AIRWORTHINESS DIRECTIVE GLIDERS:

GFA/AD/154 CAPRONI 3
T.B. No. 79.01.

SUBJECT: Pulleys for rudder control cables in the landing gear compartment.

FIG. 1

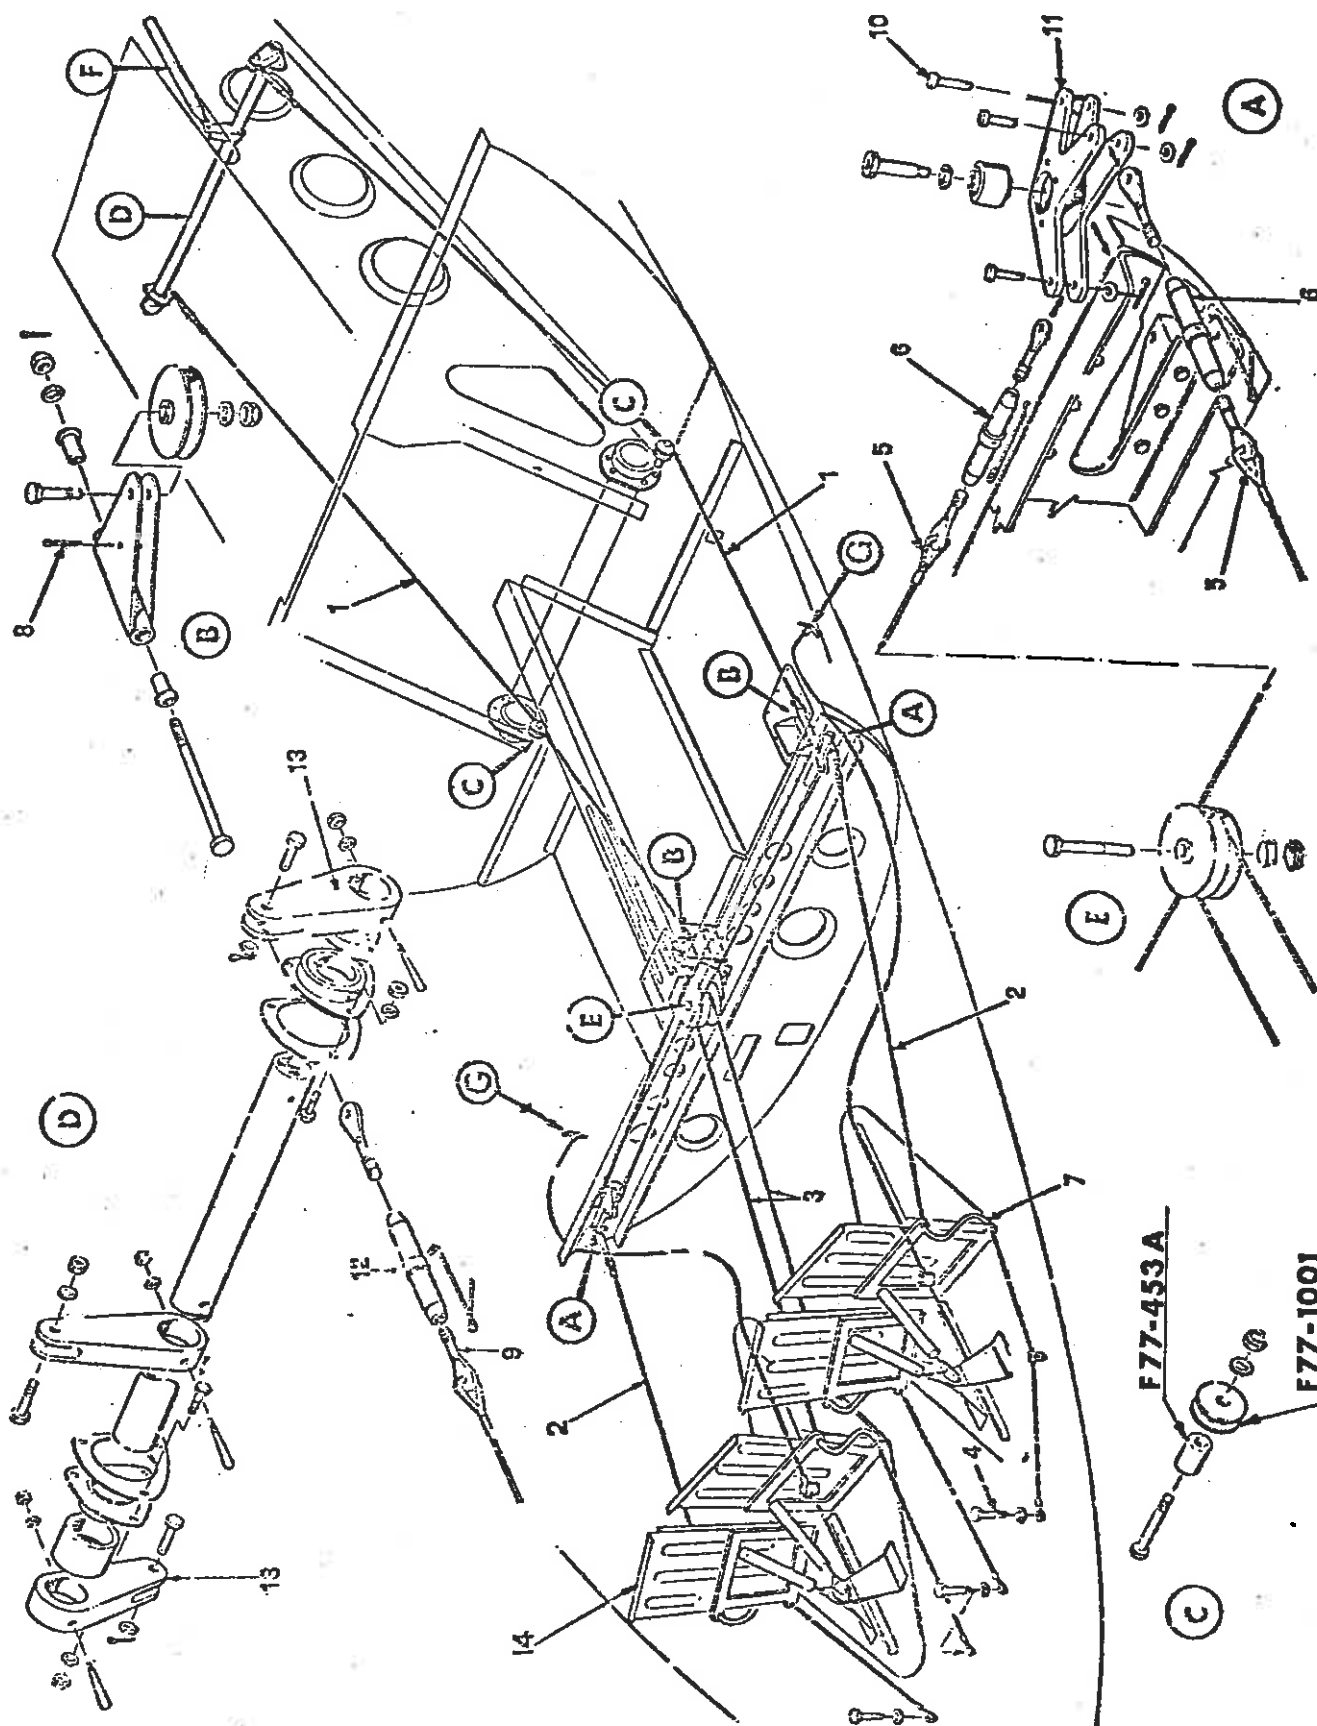
In order to prevent possible wear of the rudder control cables in the landing gear compartment below the landing gear connection (see Fig. 1 Area C) due to the pulley seizure, inspection and modification is to be effected as per instructions hereinafter described.

1. Inspect pulleys and cables for wear.
2. Pulleys C (see Fig 1) are to be replaced by Pulleys PN.F77-453A with roller bearing and relative spacer PN.77-1001 (see Fig. 2) using the existing bolt, nut and washer.
3. Maintenance Manual Section 1V, group A, para 7 to be amended to read - Periodical inspection must be carried out every 50 hours.
4. Accomplishment of the modification to be carried out by the holder of D.O.T. 1109 authorised for approved modification on the type of construction and is to be entered up in the aircraft log book.
